Project Number 694

OG-06-213

Subject: **Pressurized Water Reactor Owners Group
Responses to NRC Request for Additional Information Regarding
the Review of BAW-2461, "Risk Informed Justification for
Containment Isolation Valve Allowed Outage Time Change"
(LSC-0236)**

Example of Ganged CIVs

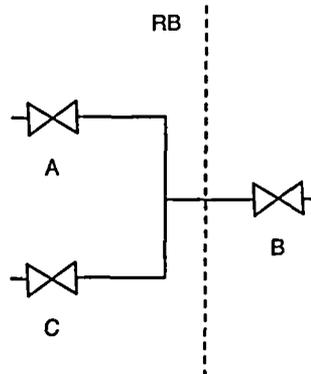
- 1) Determine if the CIV is on a penetration that has ganged CIVs; for example, some penetrations may have an outboard CIV that is in series with two or more parallel inboard CIVs (see example illustration below). If the penetration has ganged CIVs, then determine if the inoperable CIV affects one CIV pathway or multiple CIV pathways (consider only the CIVs). In the example, if CIV A is inoperable, then one flow path is affected (A:B). Similarly, only one flow path is affected for CIV C inoperable. However, if CIV B is inoperable, then two CIV flow paths are affected (A:B) and (C:B). Hence in the case of CIV B inoperable, the risk impact (from Table 3-3) is the sum of the two risk impacts, e.g., $ICLERP_{(A:B)} + ICLERP_{(C:B)}$.

Therefore, in cases where the postulated inoperable CIV is paired with multiple CIVs on the opposite side of the RB wall, perform steps 1 through 13 for each pair and sum the risk impacts.

Example of Boundary Options for Crediting Additional Valves in Risk Calculation

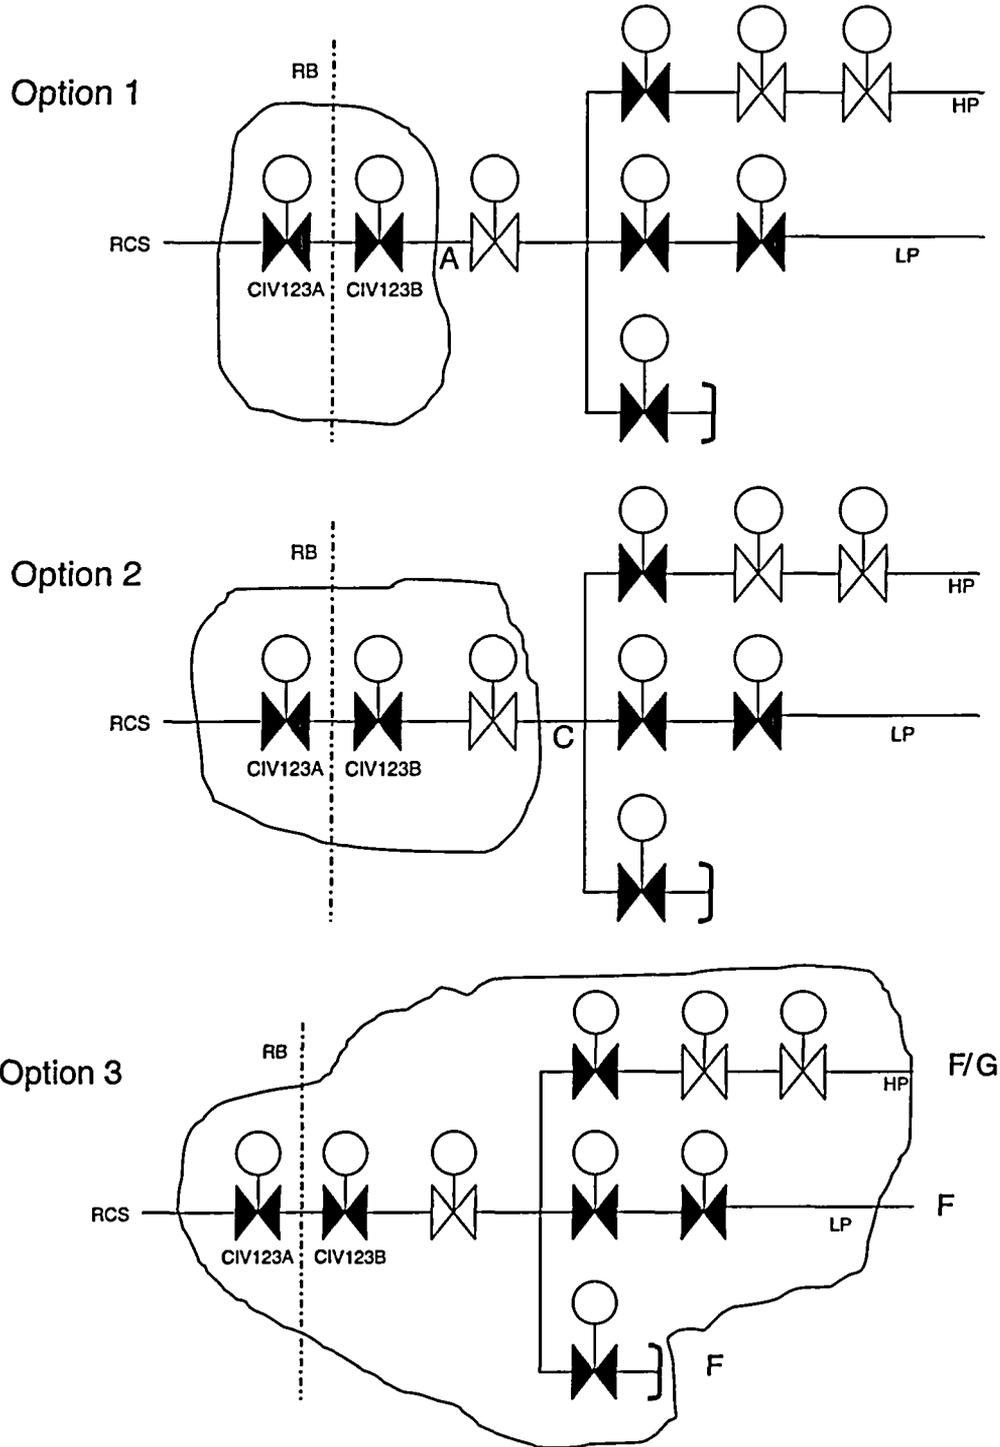
For example, see the simple example in the figure below. If the boundary is drawn around just the CIVs (option 1), then Configuration A is assumed for the outboard piping. In many cases, the open pipe assumption (A) produces acceptable risk, making it unnecessary to be concerned about the state of the system downstream of the CIVs. However, if the boundary is drawn to include the additional NO MOV (option 2), then Configuration C is assumed, improving the risk. The boundary can also be drawn larger to credit additional valves (option 3); in this case, all of the pathways have at least three additional valves (cap on pipe end is counted as a valve) before the low-pressure piping, and configuration F is used for each.
